CHEM-NUCLEAR SYSTEMS, LLC

Subj: Safety Analysis Report for the CNS 10-160B, C of C 9204, Rev. 15

SAFETY ANALYSIS REPORT
FOR
CHEM-NUCLEAR SYSTEMS
MODEL CNS 10-160B
TYPE B RADWASTE SHIPPING CASK

REVISION 17

Fig.4.1 - Allowable R-12 Gas/Air Mixture Test Leakage, cm³/sec, versus test temperature, deg.F

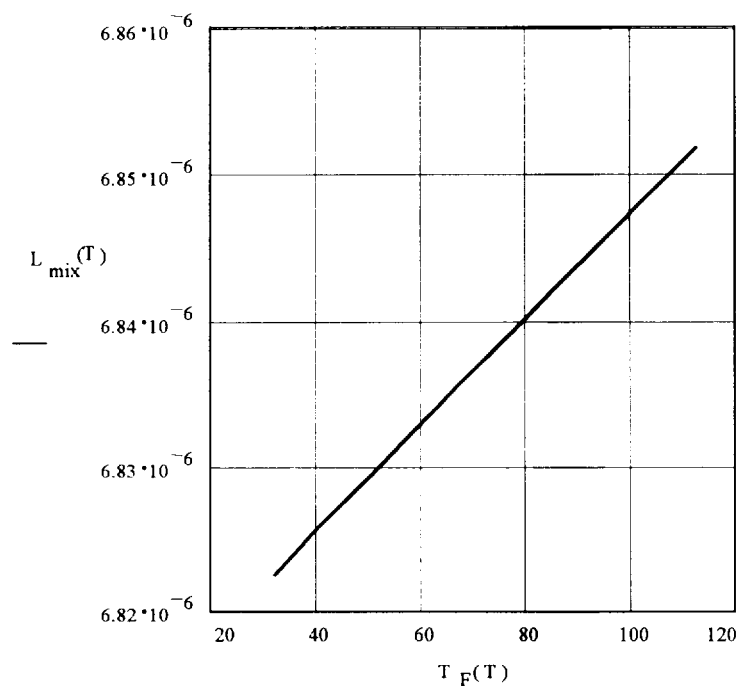
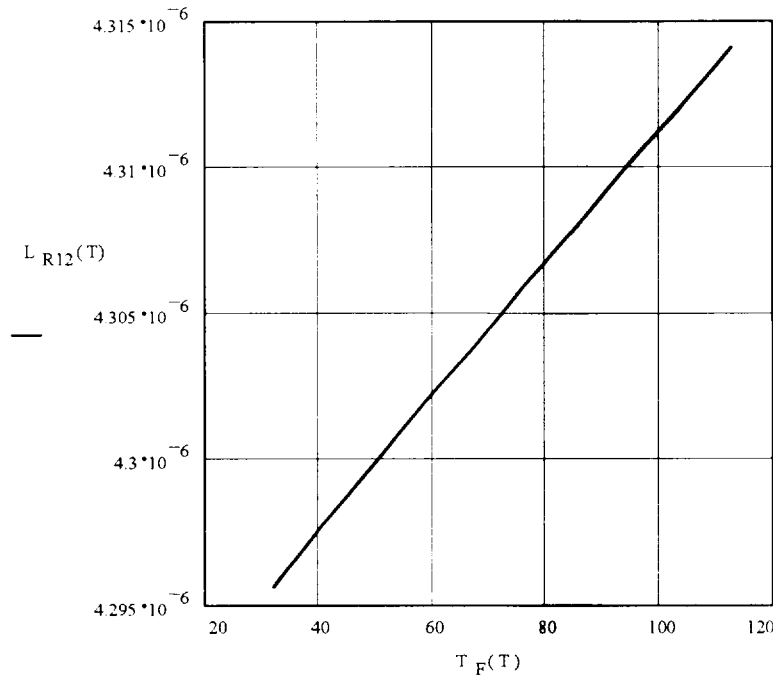
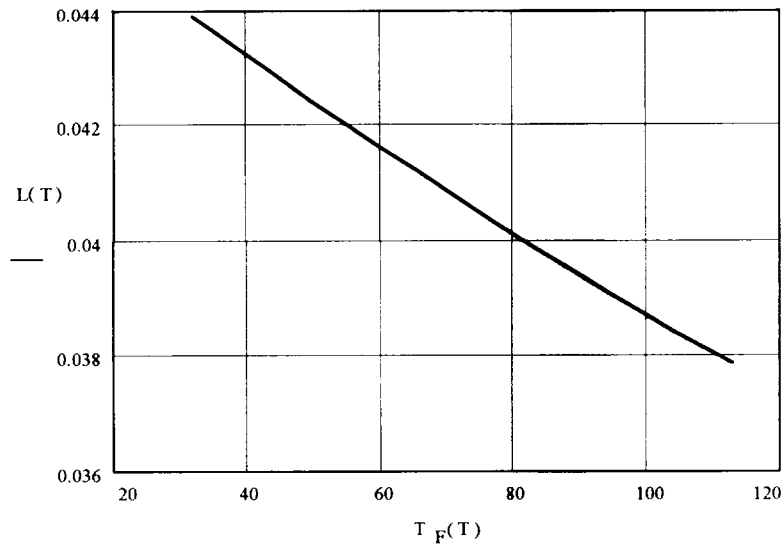
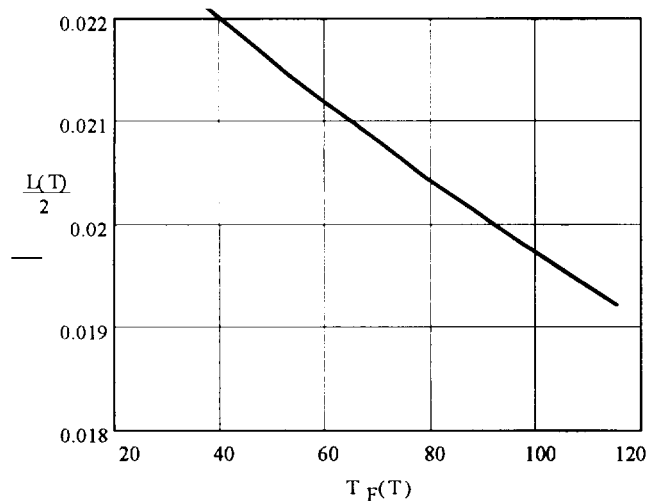
The calculations in this section have been revised for a L_{STD} based on

The values presented in Figure 4.4 should be used to determine the sensitivity to calibrate the leak detec-

Fig.4.5 - Allowable He/Air Mixture Test Leakage, cm^3/sec , versus test temperature, deg.F

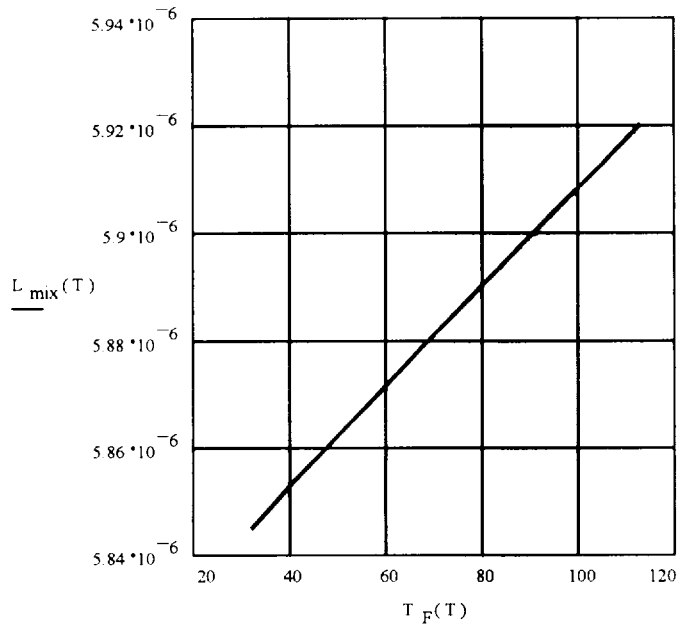
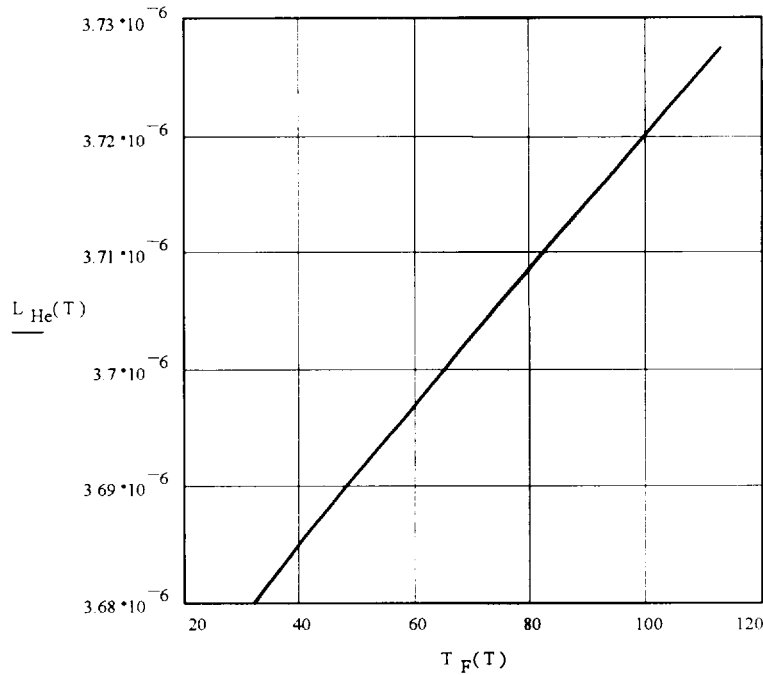
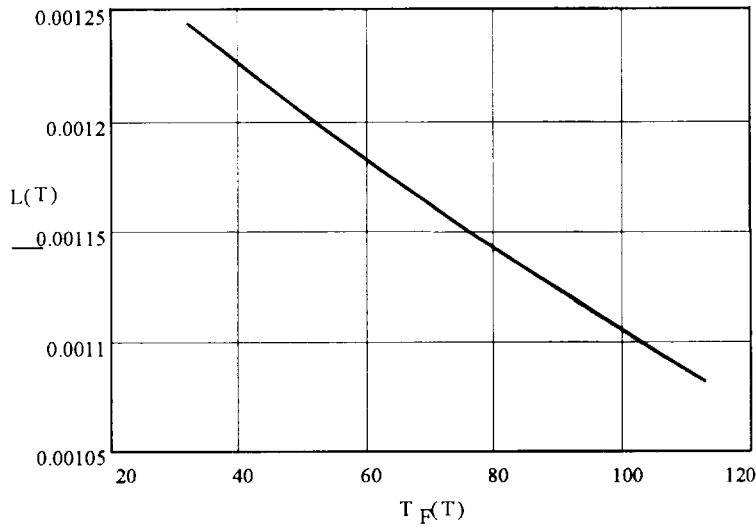
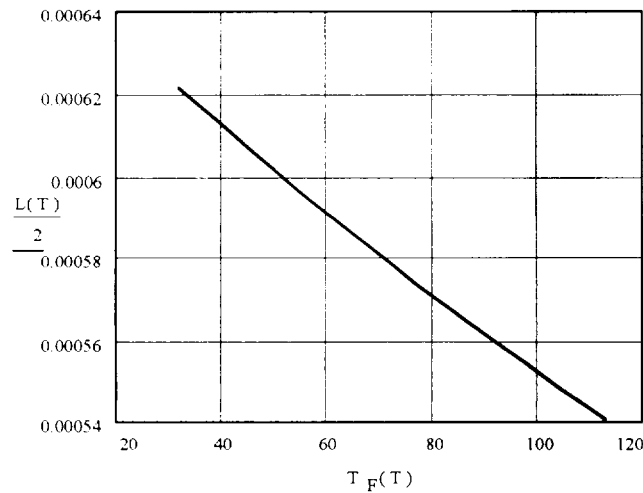
The calculations in this section have been revised for a L_{STD} based on a source term of 3000 A₂.

The values presented in Figure 4.8 should be used to determine the sensitivity to calibrate the leak detector prior to the test.
